# HOUSTON PLANNING COMMISSION

## AGENDA

JULY 19, 2018

# Houston Planning Commission **ITEM: 108**

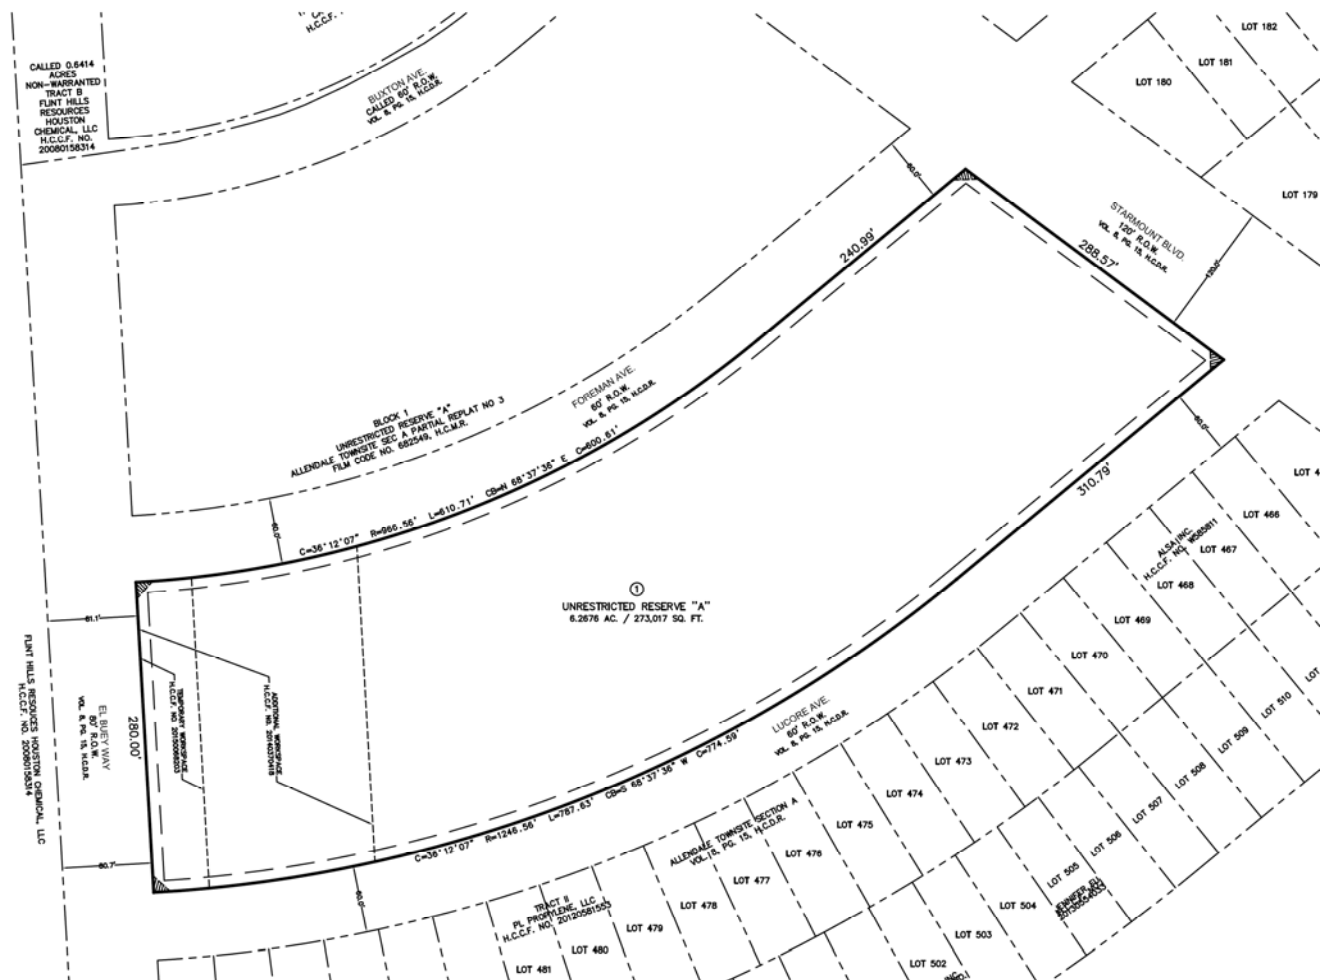
City Engineer: DETENTION IS REQUIRED
